NOTICE OF PROPOSED MULTI DWELLING HOUSING

Property: 71-73 Vicliffe Avenue, Campsie NSW 2194

Proposal: Construction of eight (8) x 2-bedroom townhouses, parking for four (4)

Subject: Council comments on Multi Unit Housing - 71-73 Vicliffe Ave Campsie - NB-2-2022 - SUB22-225676

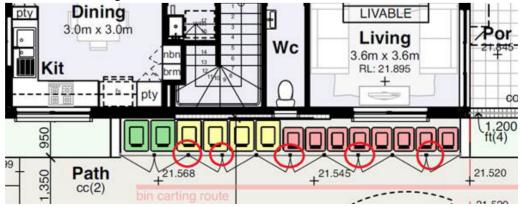
c) Communal Bin Storage Area

- i. The proposed communal bin storage area is not accepted. The bins cannot be moved out as many sit behind door hinges (circled red). Also, the bins cannot be stored outside habitable windows. Thirdly, the bins will not fit on the kerb as every second week garbage and recycling bins need to be presented -12 bins with only kerb space for 8.
- Instead provide 660L bulk bins and Council waste services can collect and return the bins from the bin storage area.
